UNITED STATES PATENT AND TRADEMARK OFFICE

APPLICATION NO.	FILING DATE	FIRST NAMED INVENTOR	ATTORNEY DOCKET NO.	CONFIRMATION NO.
10/663,653	09/17/2003	Hideki Kanie	A-9923	3807

Office Action Summary

DETAILED ACTION

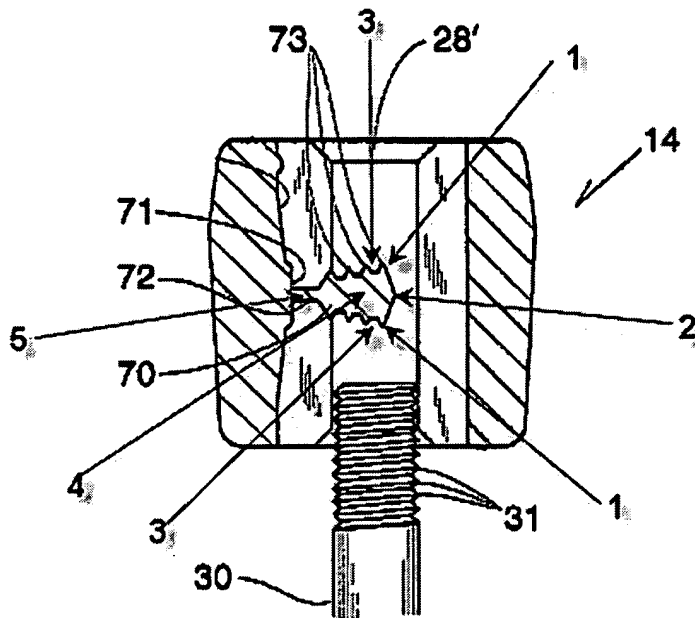
As for Claim 1, Geiger teaches (Fig. 15) (also see figure below) of a device (14) to be attached to a threaded stud (30), comprising a body having a bore (28') for insertion of a stud (30), wherein the device (14) has only a single pawl (70), and, in the absence of a stud (31) in the

bore (28'), the pawl (70) extends from an inner wall (71) of the bore (28') in a direction substantially perpendicular to an axis of the bore (28'), wherein the pawl (70) has a flexible thin section (5) connected to the inner wall (71) and a thick section (4) extending from the thin section (5), wherein the pawl (70) can be bent in opposite directions at the thin section (5) for mounting the device (14) on a stud (30) from two directions, wherein a single pair (1) of thread engaging sections (73) are formed at opposite sides of a tip end (2) of the thick section (4), one or another of the engaging sections (73) being disposed for entering a space between crests of threads (31) of a stud (30) depending on a direction of insertion of the stud (30) in the bore (28'), wherein a single pair of grooves (3) are formed adjacent to corresponding engaging sections (1) of the pawl (70), each groove (3) being disposed for receiving a crest of a thread (31) adjacent to the space between the crests, and wherein the thick section (4) of the pawl (70) between the grooves (3) and the thin sections (5) is devoid of thread engaging sections and grooves corresponding to thread engaging sections.

As for Claim 3, Geiger teaches (Fig. 15) (also see figure above) of a device (14) to be attached to a threaded stud (30), comprising a body having a bore (28') for insertion of a stud (30), wherein the device (14) has only a single pawl (70), and, in the absence of a stud (31) in the bore (28'), the pawl (70) extends from an inner wall (71) of the bore (28') in a direction substantially perpendicular to an axis of the bore (28'), wherein the pawl (70) has a flexible thin section (5) connected to the inner wall (71) and a thick section (4) extending from the thin section (5), wherein the pawl (70) can be bent in opposite directions at the thin section (5) for mounting the device (14) on a stud (30) from two directions, wherein a pair (1) of thread engaging sections (73) are formed at an end (2) of the thick section (4), one or another of the engaging sections (73) being disposed for entering a space between crests of threads (31) of a

stud (30) depending on a direction of insertion of the stud (30) in the bore (28'), wherein a length of the thick section (4) of the pawl (70) is substantially greater than a distance between the inner wall (71) and a stud (30) inserted in the bore (28'), and wherein after insertion of a stud (30) in the bore (28'), a centerline of the pawl (70) forms an angle substantially less than 90° from the centerline of the pawl (70) before insertion of a stud (30).

As for Claim 6, Geiger teaches (Fig. 15) (also see figure above) of a device (14) to be attached to a threaded stud (30), comprising a body having a bore (28') for insertion of a stud (30), and having only a single pawl (70) in the bore (28'), wherein the pawl (70) is connected by a hinge (5) to a first inner wall (72) of the bore (28'), wherein the pawl (70) has a centerline extending in a first direction substantially perpendicular to an axis of the bore (28') before insertion of a stud (30) in the bore (28') and forming an angle of substantially less than 90° with respect to the first direction after insertion of the stud (30) in the bore (28'), and wherein the pawl (70) has a thread engaging section (73) at a pawl tip (2) that enters a space between successive crests of threads (31) of a stud (30) and has an adjacent groove (3) that receives one of the crests of the thread (31), wherein the pawl (70) has a length (via 4) between the groove (3) and the hinge (5) that is devoid of thread engaging sections and thread crest receiving grooves, and wherein a second inner wall (inside 22) of the bore (28') is constructed to minimize lateral

movement of the stud (30) in the first direction, and in a direction orthogonal to the first direction.

Re: Claim 7, wherein the second inner wall (inside 22) of the bore (28') is dimensioned to closely surround a major portion of the circumference of the stud (30).

Re: Claim 8, wherein the engaging section (73) and the groove (3) are formed on a section of the pawl (70) substantially thicker (4) than a section of the pawl (70) forming the hinge (5).

Re: Claim 9, wherein there are a pair (1) of the engaging sections (73) and a pair of the grooves (3) at opposite sides of the thicker section (4) of the pawl (70), whereby an engaging section (73) and a groove (3) can engage threads (31) of the stud (30) irrespective of the direction of insertion of a stud (30) into the bore (28').

Re: Claim 10, wherein tips of the engaging sections (73) and the grooves (3) are arcuate to conform to the curvature of the threads (31) of the stud (30).

[6] Applicant's arguments filed 6/26/2006 regarding rejections under 35 U.S.C. 102 have been fully considered but they are not persuasive. Examiner maintains that the amended subject matter presented by applicant in the instant amendment is still anticipated by the prior art of

Geiger. A figure has been provided (see above) to help show that the structure of Geiger does indeed anticipate that of the claims. It is the claims that define the claimed invention, and it is claims, not specifications that are anticipated or unpatentable. *Constant v. Advanced Micro-Devices Inc.*, 7 USPQ2d 1064. Applicant states that Geiger does not teach of a single pair of thread engaging sections formed at opposite sides of a tip end of the thick section and a single pair of grooves formed adjacent to corresponding engaging sections. The examiner disagrees. Geiger does indeed disclose of a single pair (1) of thread engaging sections (73) formed at opposite sides of a tip end (2) of the thick section (4) and a single pair of grooves (3) formed adjacent to corresponding engaging sections (1) (73) (see figure above). Applicant goes on to state numerous other features from the applicants claimed invention that he believes is not anticipated by the structure of Geiger. Examiner disagrees, and directs the applicant once again to the claim rejection section above where it is distinctly shown how each and every claimed element is disclosed and anticipated by the structure of Geiger.
